VE No. 5

VALUE ENGINEERING CHANGE PROPOSAL
MISSOURI DEPARTMENT OF TRANSPORTATION

Contract ID 090626-601 Job No. J6I1830B

Subject: Rejection Recommendation – VE No. 5 (Dorsett)
Job No.: J6I1830B
Route I-270 – St. Louis County
Contract ID: 090626-601

TYPICAL SECTIONS
SHEET 4 OF 5

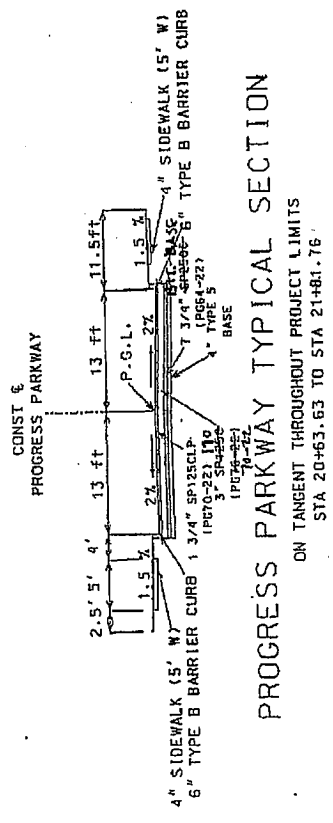
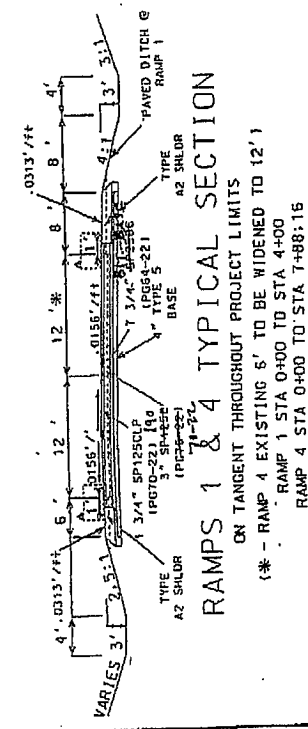
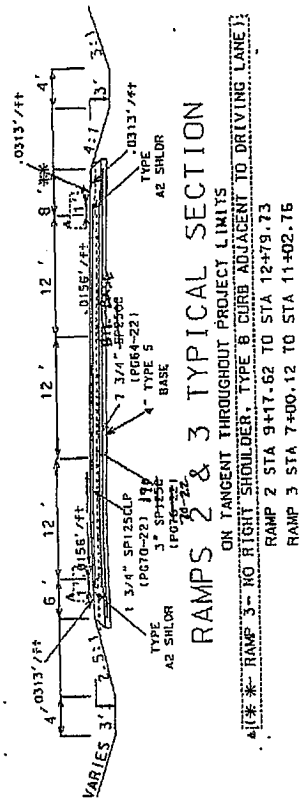
REJECTION RECOMMENDED: Due to traffic volumes, stops and starts, and after consulting with the Pavement Engineer, we do not feel substituting 3" BP-1 (64-22) for 3" SP250 (70-22) nor 9" Bit Base (64-22) for 9" SP250 (64-22) is acceptable. Not only is it not equal or better, it is not practical design. It is illadvised. The proposal claims this to have bee done on I-64 but the proposal does not accurately reflect the I-64 design. We are open to consideration of using existing pavement but not mix substitution.

One more thing. In the text you reference 9"Bit Base, 3"BP-1 and 1.75"SP125. However, the typical you modified shows 0" Bit Base, 3"SP190 and 1.75SP125LP

Are you proposing the 3" layer be 1) BP-1 with PG70-22 2)BP-1 with PG64-22 or 3)SP190 with PG70-22

Are you proposing to change the surface from an LP mix to a straight SP125?

With the VE, Weber is proposing 9.25" Bit-Base (64-22), 3" BP-1(64-22) and 1.75" SP125LP(70-22).

John, what do you think? Looks to me like the \$66,000 savings comes mostly from reducing the binder grade in the 3" course and using Bit Base and BP-1 instead of superpave. It sounds to me like if we required the planned typical, it would actually cost more than the concrete alternate they bid.

We have reviewed the concept you submitted to utilize part of the existing pavement and switch to full depth asphalt on Dorsett, henceforth known as VE No. 5, and have some concerns. We will not allow the use of Bituminous Pavement, Bituminous Base or a lesser grade of binder as described in your proposal. Traffic volumes, truck volumes, stops, starts and turns at this interchange are not conducive to lesser mixes than originally designed. You pointed out that this had been used on I-64 and after some investigation, we found that it was a little different than what you propose. Bituminous base is being used in some locations on I-64 as the binder course, however it is not a typical Bituminous Base. It is designed with a gyratory compactor rather than a Marshall hammer and contains manufactured sand rather than river sand. In addition, Bituminous Pavement (BP-1, PG64-22) is not being used as an intermediate lift. The top two lifts are SP125, PG70-22.

SAMPLED: 08/07/09

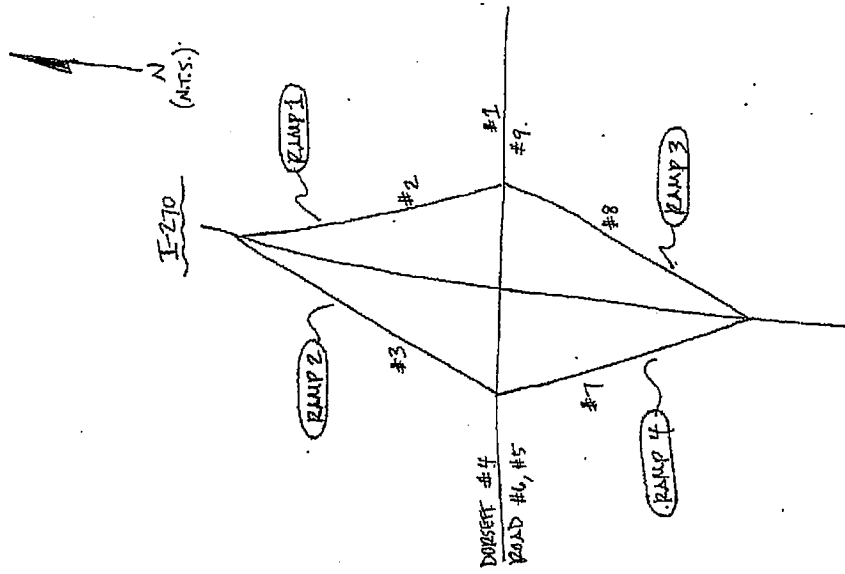
Core samples were taken of the existing pavement on the Ramps as well as Dorsett Road. The attached sketch indicates the location and thickness of the cores which were extracted on 08/07/09. The underlying concrete is in sound condition and should provide a good base for the overlay sections that are being proposed. The existing asphalt will be milled down to concrete or to a depth that allows for 3-3/4" of asphalt cover. Subgrade elevations of the adjacent full-depth pavement will likely have to be adjusted to match.

I had Weber cut some cores, little info was provided besides thickness of asphalt and concrete. Should this CONCEPT be approved. MoDOT will do some coring, look at base-rock thickness and perform California Bearing Ratio testing on subgrade prior to making a final decision on approval of the VE.
